WILLISTON, VERMONT

CERTIFICATE OF APPROPRIATENESS

HP 24-04

Historic and Design Advisory Committee (HDAC) Staff Report

Figure 1. Blue = existing slate. Orange = existing shingles.

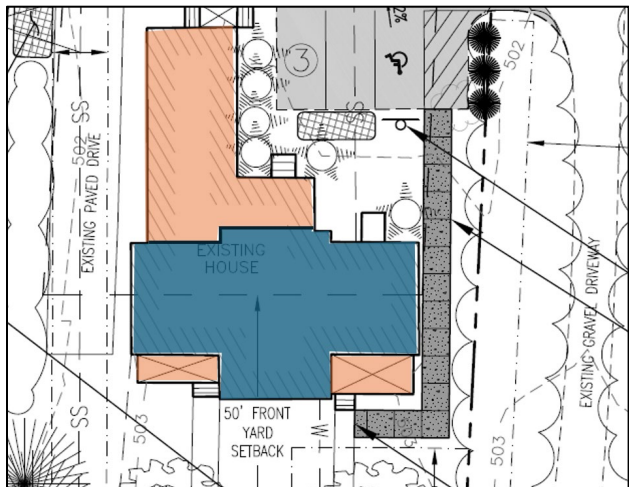
HDAC Recommendation to DRB:

- Material consistency between main block roof and porch/addition roofs is preferred if a non-slate material is required for main block.
- Materials preferred: Asphalt shingles, artificial or real slate

Staff Recommendation to HDAC: First, the HDAC should decide if enough information is provided. At the time of agenda posting on 6/26, the applicant had not submitted information about the proposed material brand/specifications or photos of the existing roof. This information may be available before or at the 7/2 meeting. If more information (or more time to review) is needed, the HDAC may continue to July 16th. Second, the HDAC should consider the guidance of Appendix H and issue a recommendation for the DRB to consider. **July 2nd update:** See pages 8-18, which were provided this morning. The applicant has provided options for metal roofing and an article with several asphalt shingles options that look like slate.
